A Review of the Limerick Generating Station Severe Accident Risk Assessment

Review of Core-Melt Frequency

Brookhaven National Laboratory

Prepared for
U.S. Nuclear Regulatory
Commission

Figure 3.1.5 Seismic event tree for loss of offsite power without scram.

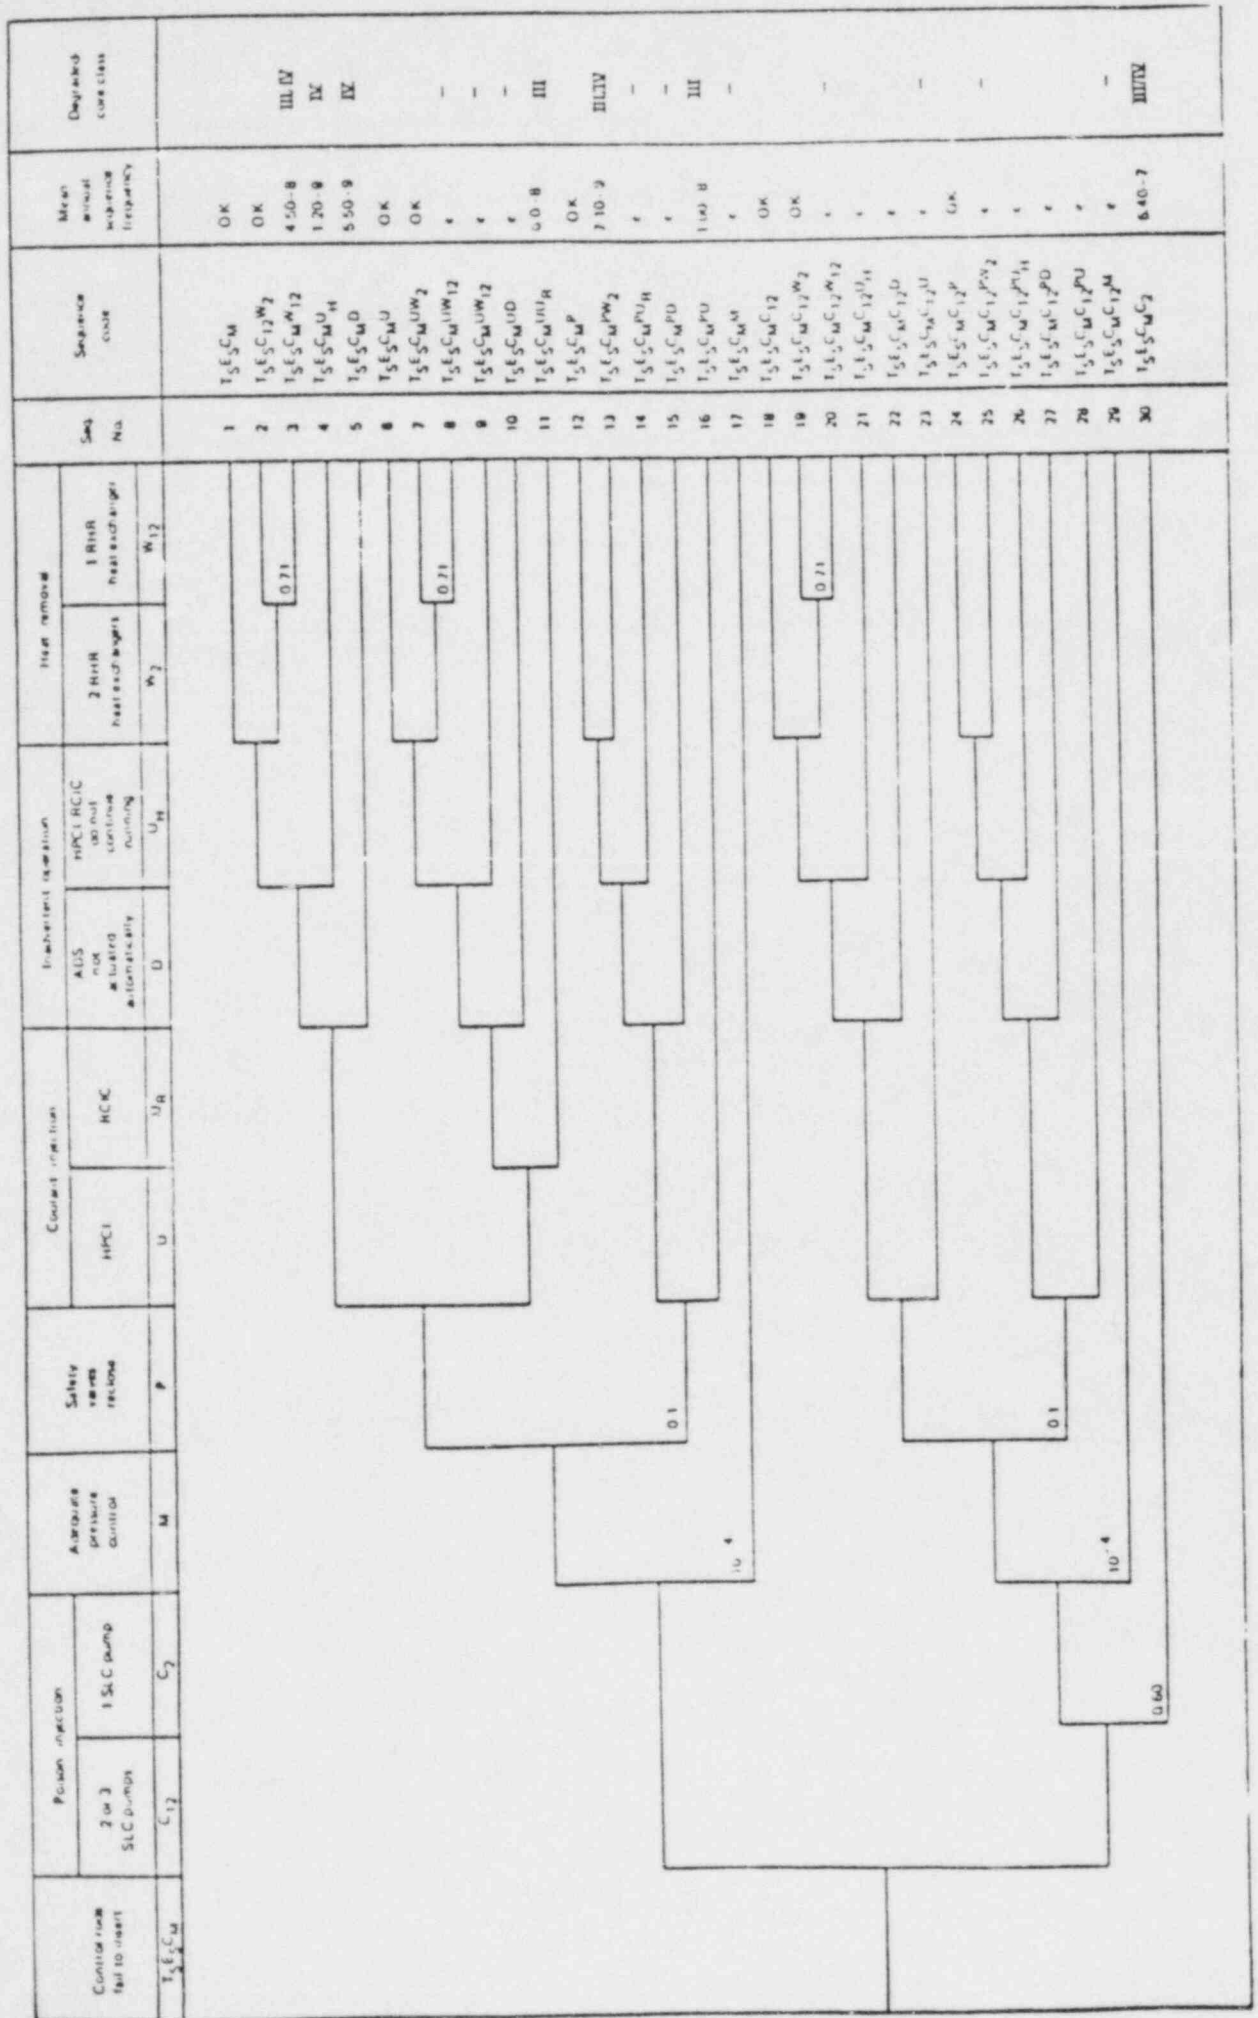
If, in the reactor transient, there is a failure to scram, an event tree similar to Figure 3.1.5 should be developed. It is conceivable that the contribution to risk due to Class V sequences may not be negligible. It is recommended that these considerations of additional accident sequences should be addressed in the LGS-SARA.

BNL reviewed the LGS-SARA ATWS event tree and found that, in addition to those two dominant ATWS sequences, $T_S^{E_S C_M C_2}$ and $T_S^{R_B C_M}$, the contribution to core damage from other ATWS sequences defined in Figure 3.1.5 is relatively small. However, with the BNL definition of C_M , there will be about a factor of 5 increase for all the ATWS sequences in Figure 3.1.5. The total ATWS core-damage frequency reported in LGS-SARA is 8.1×10^{-7} ; by eliminating the PCR and using the BNL C_M definition, the total ATWS core damage becomes approximately 4.0×10^{-6} . This does indicate that the ATWS results are quite sensitive to the parameters used to define the failure of scram. PECO believed that it is conservative in assuming that those failure modes defined for the reactor internals and the CRD guide tubes will directly cause a failure to scram. BNL tends to agree that the definition of failure modes of these components may be conservative and would encourage additional analysis to support the LGS-SARA assumptions. A refined analysis in this area is needed since it will have significant impact on the acute and latent fatalities.

Figure 3.2.1 Fire-growth event tree for fire zone 2

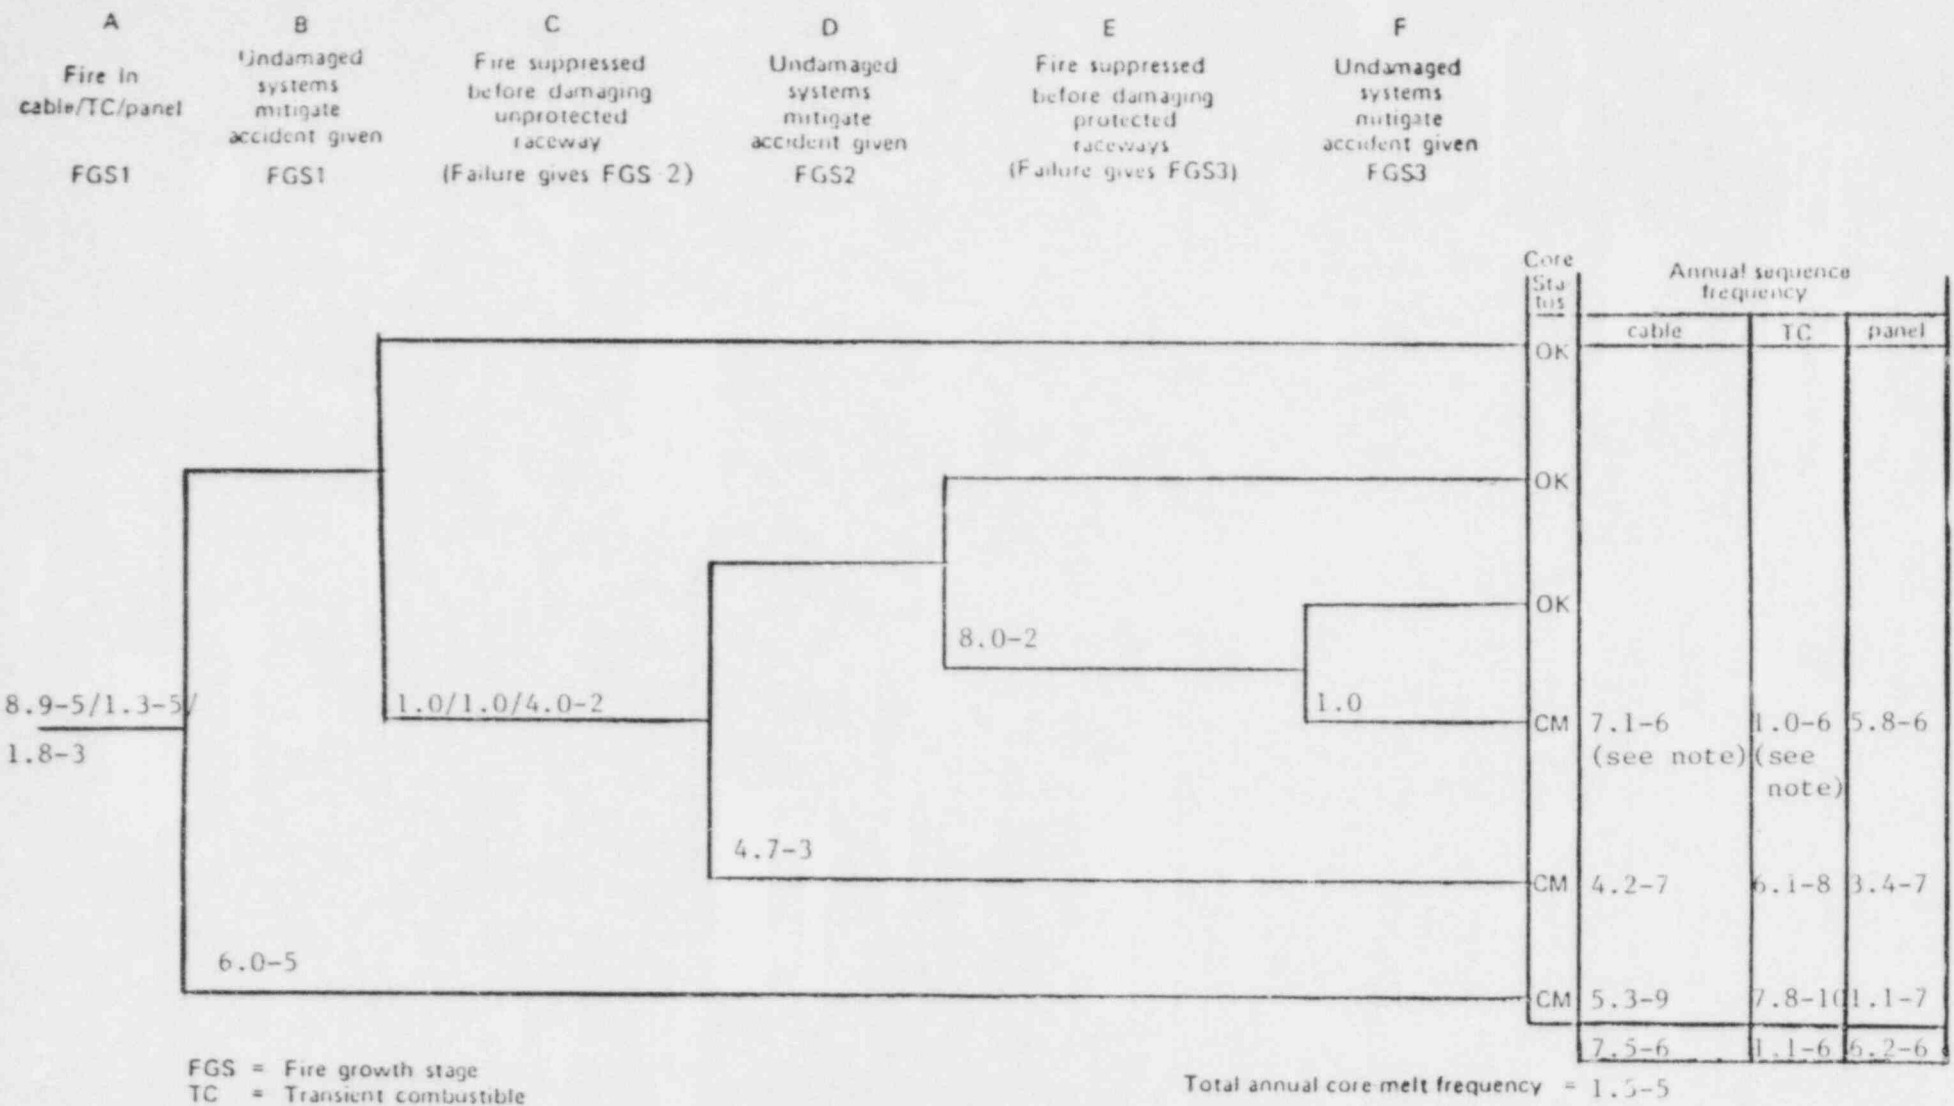
The fire growth event tree for Fire Zone 2 is shown in Figure 3.2.1, and the evaluation of the branch point probabilities is discussed below.

The fire growth event tree for panel fires is also shown in Figure 3.2.1, and the evaluation of the branch probabilities follows.

The fire growth event tree for transient-combustible fires is also presented in Figure 3.2.1, and the evaluation of the branch probabilities follows.
